Re: St. Lucie Unit 1
Docket No. 50-335
Response to Request for Additional Information
Unit 1 Third Interval Relief Request 32

**St. Lucie Unit 1
THIRD INSPECTION INTERVAL
RELIEF REQUEST NUMBER 32, REVISION 1**

**Relief Request
In Accordance with 10 CFR50.55a(g)(5)(iii)**

RC-103-FW-2000
Figure 12

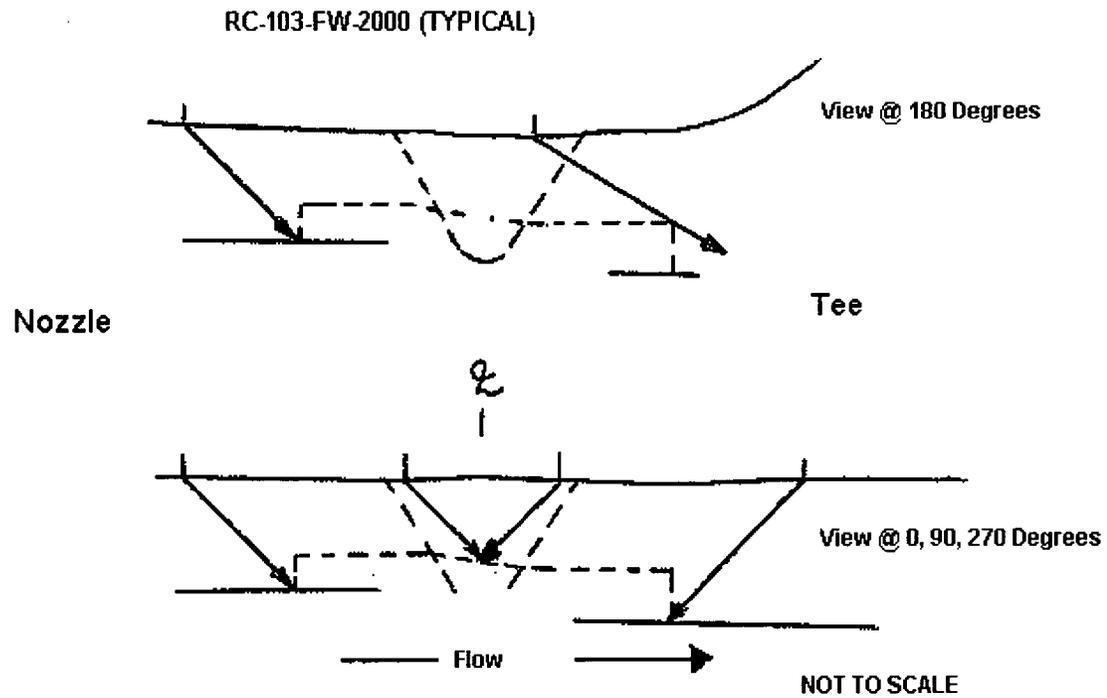
Tee to Nozzle	RC-103-FW-2000 (4"-160) Stainless Steel	2005	Exam Category B-J/R-A Item No. B9.11/R1.11 Fig. IWB-2500-8 84.5% volume coverage	45S 60S 60L	12	PSI examination limited by configuration. Examination complete of the nozzle side and scanning limited from the tee side in area of radius. Best effort examination of tee side in area of radius performed through weld material.

SI-129-FW-1
Figure 19

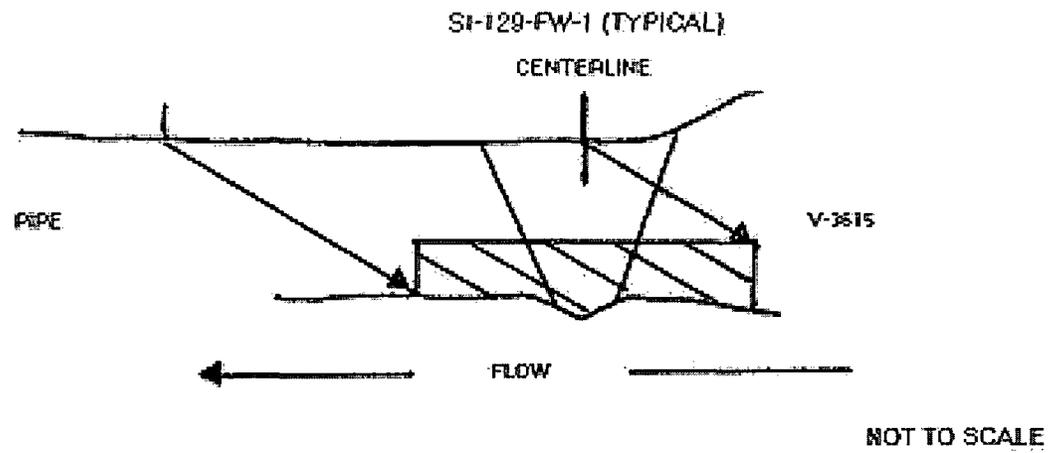
Valve to Pipe	SI-129-FW-1 (6"-160) Stainless Steel	2002	Exam Category C-F-1 Item No. C5.11 Fig. IWC-2500-7(a) 50% volume coverage	45S 60S 60L	19	Inservice examination limited by configuration. Examination complete of the pipe side and best effort examination of valve side performed through weld material. No access for scanning from valve side due to valve taper, and valve configuration.

SI-212-FW-1
Figure 22

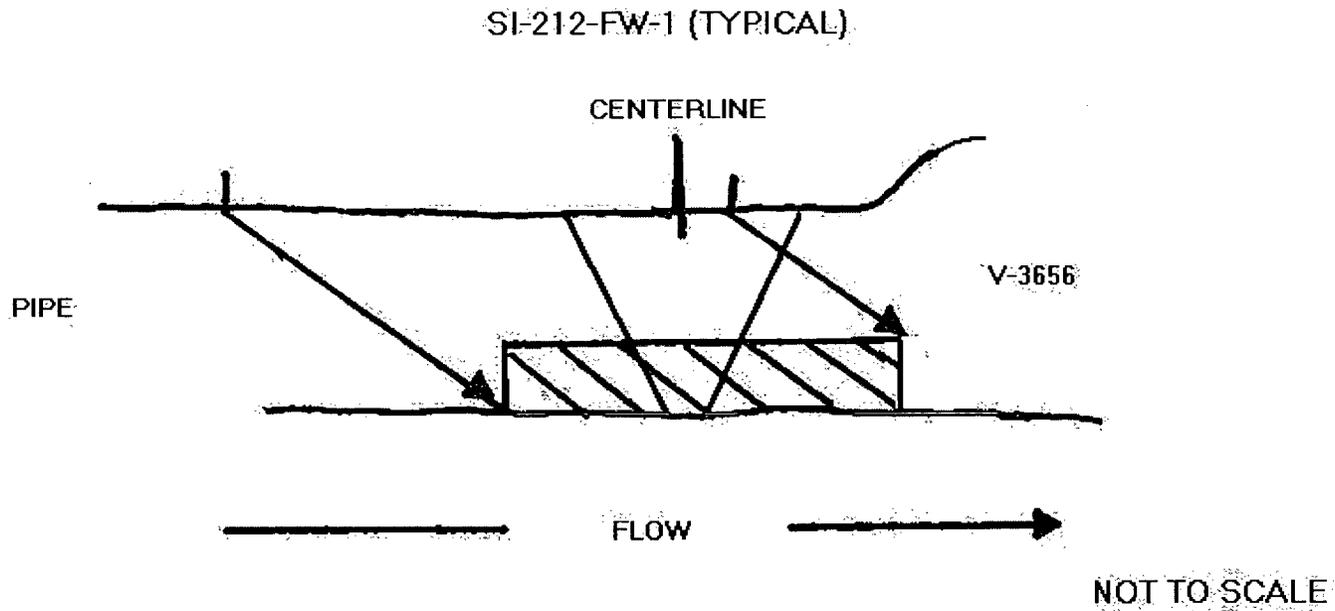
Pipe to Valve	SI-212-FW-1 (6"-160) Stainless Steel	2002	Exam Category C-F-1 Item No. C5.11 Fig. IWC-2500-7(a) 50% volume coverage	45S 60S 60L	22	Inservice examination limited by configuration. Examination complete of the pipe side and best effort examination of valve side performed through weld material. No access for scanning from valve side due to valve taper, and valve configuration.

SI-210-FW-4
Figure 25

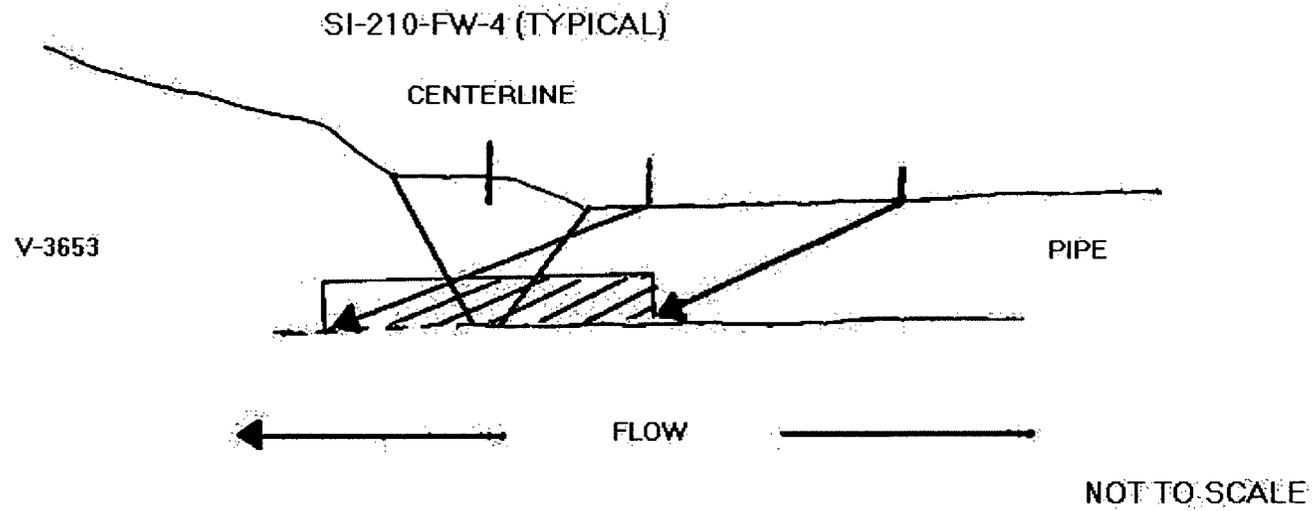
Valve to Pipe	SI-210-FW-4 (4"-80) Stainless Steel	2004	Exam Category C-F-1 Item No. C5.21 Fig. IWC-2500-7(a) 50% volume coverage	45S 70S	25	Inservice examination limited by configuration. Examination complete of the pipe side and best effort examination of limited amount of valve side performed through weld material. No access for scanning from valve side due to weld crown, valve taper, and valve configuration.
